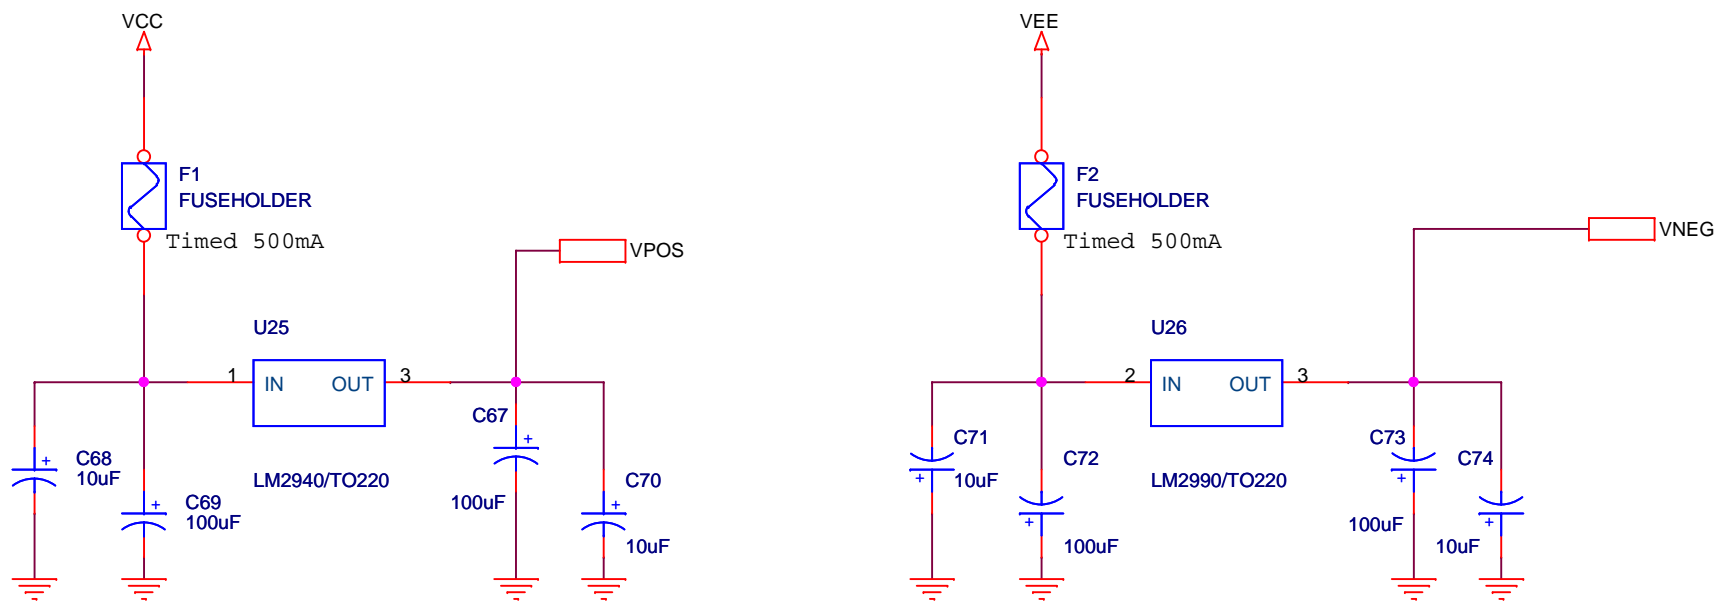
Added a 15V zener between pin 1 (Cathode) & 3 (Anode) of U25 in order to avoid a latch-up problem at startup
 (Use + holes of C68 and C70)

C68, C67, C70, C71, C73, C74 not placed
